Joint Planning and Housing Committee & Agriculture and Rural Affairs Committee Motion

Item / Article: 3.1 Provincial Planning Statement 2024 - Consistency Amendments

Re: Revisions to Old Ottawa East Secondary Plan Amendments

Revised Amendments to Document 1 – Appendix B: Volume 2 Amendments

Secondary Plan Schedule A - Designation Plan

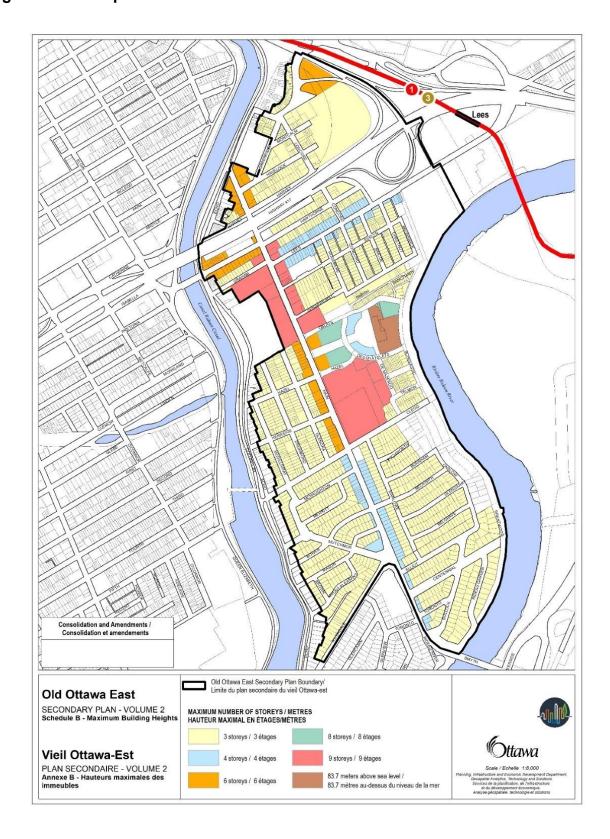
the application of the angular plane to a Neighbourhood Low-Rise designation.	
2.39	As shown in Appendix D, Schedule E of this Official Plan amendment, secondary plan Schedule A – Designation Plan is amended.	The revised schedule retains the 40-metre frontage of 140 Main Street (Immaculata High School) within the secondary plan with a Mainstreet designation. Although 140 Main Street is a listed heritage property, the lands closer to Main Street are vacant and staff do not have concerns with them remaining within the secondary plan.

Revised Old Ottawa East Secondary Plan Schedule B – Maximum Building Heights that incorporates the revisions noted in amendment 2.40.

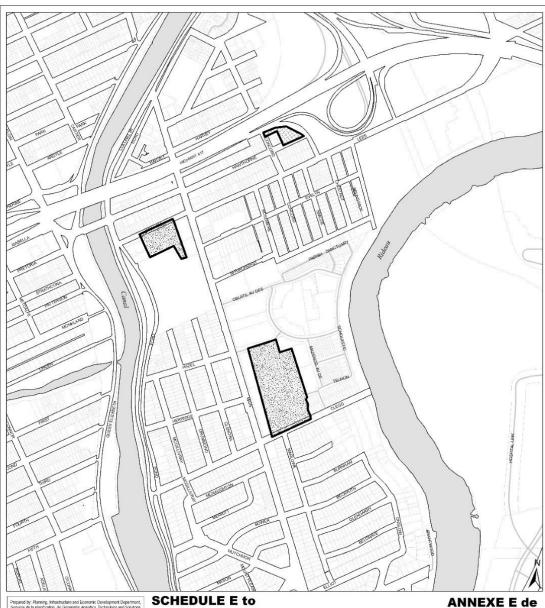
2.40	As shown in Appendix E, Old Ottawa East Secondary Plan Schedule B — Maximum Building Heights is deleted and replaced with the following changes from the original staff recommendations: i. Show the frontage along 140 Main Street (Immaculata High School) up-to 40-metres deep as 9 storeys ii. Remove the 4 storey height maximum at 321 Main Street (Children's Garden) with no colour shown on the property iii. For 155 Hazel Street and 175 Main Street, show 8 storeys as per Area B on the existing Schedule B — Maximum Building heights, and 6 storeys between Main Street and the westerly edges of Area B. iv. Show 9 storeys at 530 and 570 de Mazenod Avenue	The 40-metre frontage of 140 Main Street (Immaculata High School) is retained within the secondary plan_with a 9-storey maximum building height. Although 140 Main Street is a listed heritage property, the lands closer to Main Street are vacant and staff do not have concerns with them being developed within the framework of the secondary plan rather than the Rideau Canal Special District. The 4-storey height permission is removed from 321 Main Street (Children's Garden). This corrects an error as the parcel is a greenspace. The existing height permissions for 155 Hazel Street and 175 Main Street are retained. The westerly portions of the sites would allow for up to 6-storeys while the easterly portions

would allow up to 8-storeys. The Deschâtelets Building is designated under part IV of the Ontario Heritage Act. The Grande Allée leading to the building is an important component of the designation. The previously proposed changes to the heights along the Grande Allée would have potentially changed the symmetry of the landscape, therefore, it is recommended that the existing heights be retained 530 and 570 de Mazenod Ave are provided with 9-storey planning permissions in association with the Mainstreet Corridor. This corrects an error where the parcels were previously proposed without a specific height.
